# CITY OF BELOIT

## REPORT TO THE BELOIT LANDMARKS COMMISSION

**File Number:** COA-2010-26

1 OF 1  
 SHEET NO.  
**BELOIT COLLEGE SIDEWALK & PARKING IMPROVEMENTS**  
 CITY OF BELOIT  
 ROCK COUNTY, WISCONSIN  
 30910.DWG

OVERVIEW

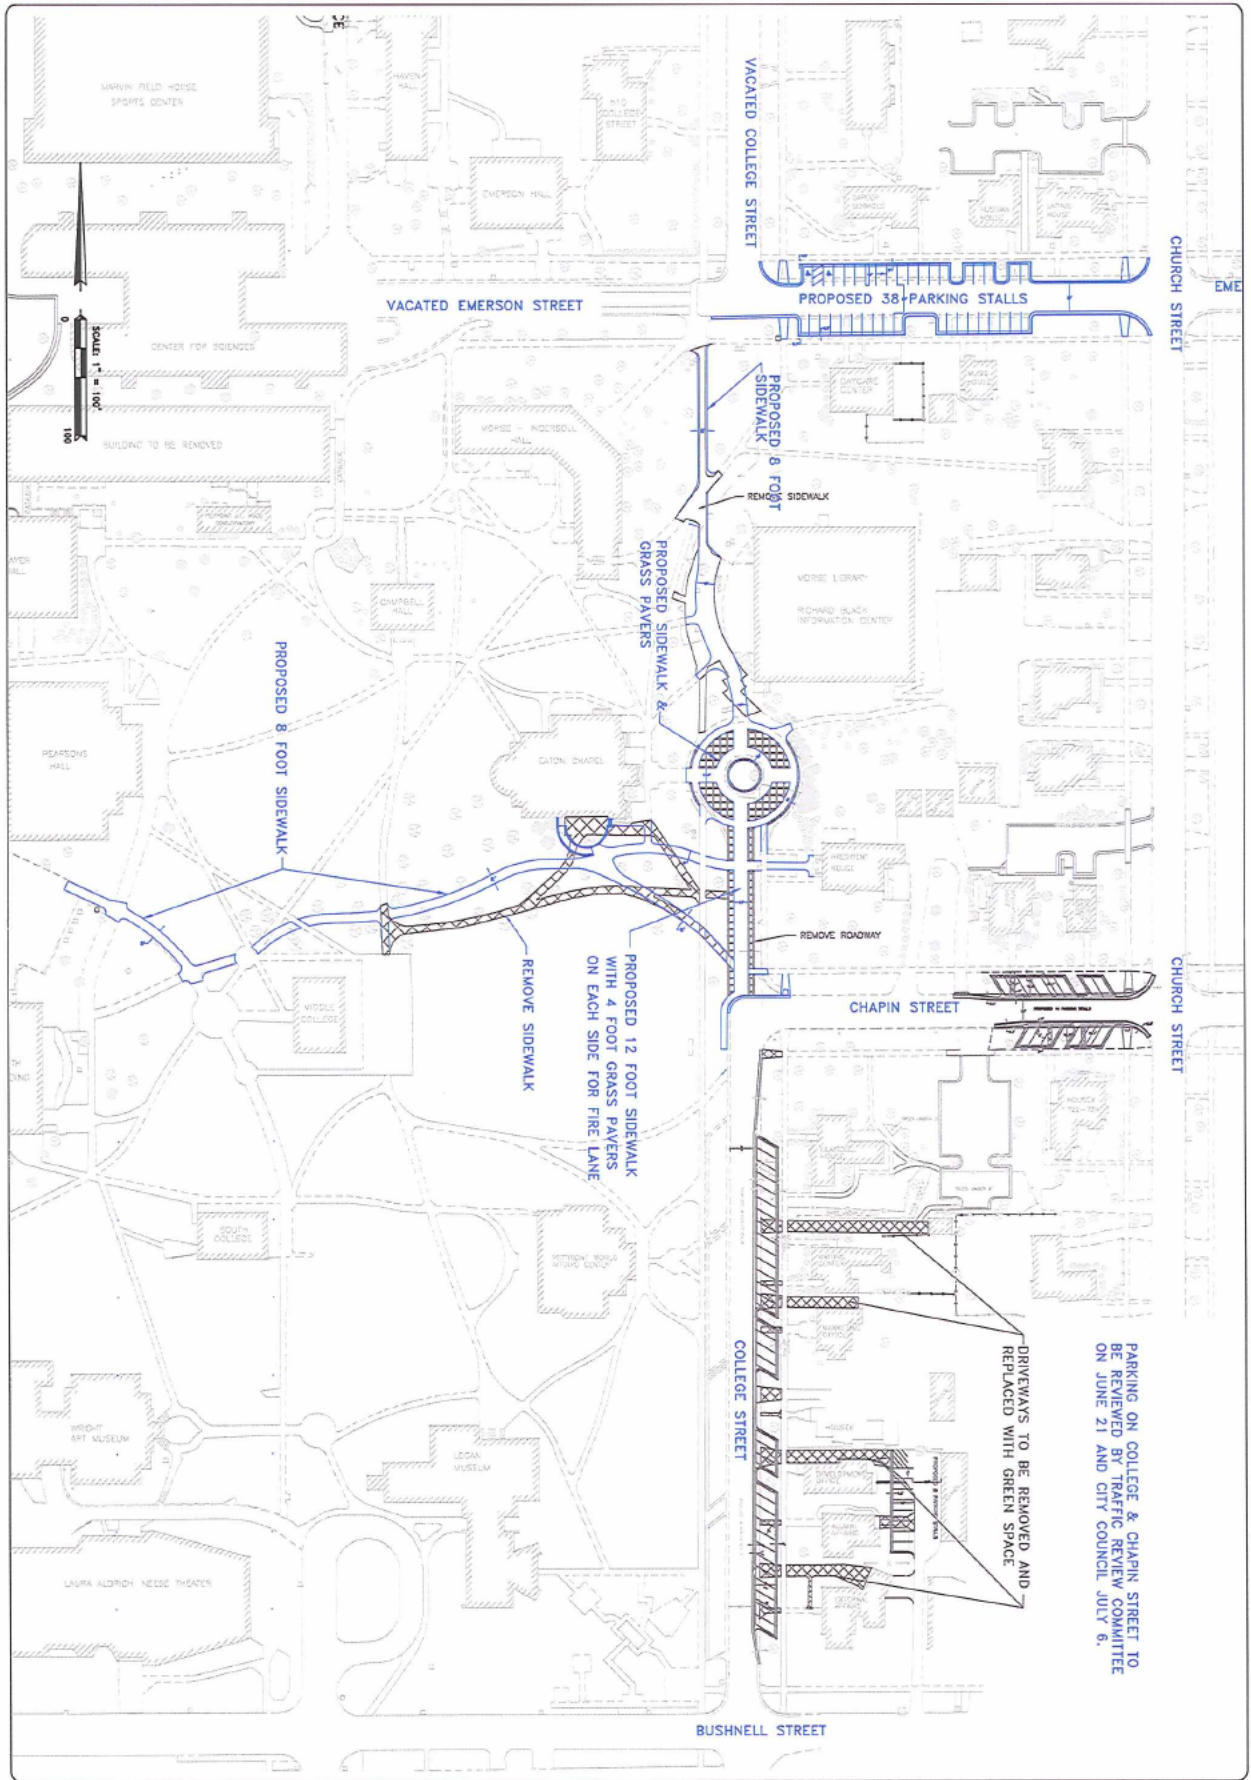
- As shown on the Overview Plan, the applicant intends to replace, remove, widen, and/or install several sidewalks.
- In addition, the applicant intends to remove the private cul-de-sac adjacent to Eaton Chapel and Morse Library. The cul-de-sac will be replaced with a wide (12') sidewalk and pavers that will maintain the fire lane.

- Because of the additional parking along the eastern side of College Street, the applicant has proposed the removal of several driveways and portions of several sidewalks, as shown on the Overview Plan. The driveway for the only remaining private residence (623 College Street) will remain. The multi-stall garage on the property located at 619 College Street will be accessible from Bushnell Street, and the applicant has proposed additional parking stalls in the grassy area behind the buildings located at 619 and 613 College Street.

1. Prior to beginning construction of the parking stalls, the applicant shall obtain a Certificate of Zoning Compliance.
2. The applicant shall maintain a twenty (20) foot fire lane through the area currently occupied by the private cul-de-sac.

3. The proposed sidewalks shall be constructed of cement and shall be at least six (6) feet wide.
4. Following removal of each College Street driveway, the applicant shall plant a deciduous tree in its place whose trunk is at least two (2) inches in diameter when measured six (6) inches above grade and twelve (12) feet in height or greater when planted.
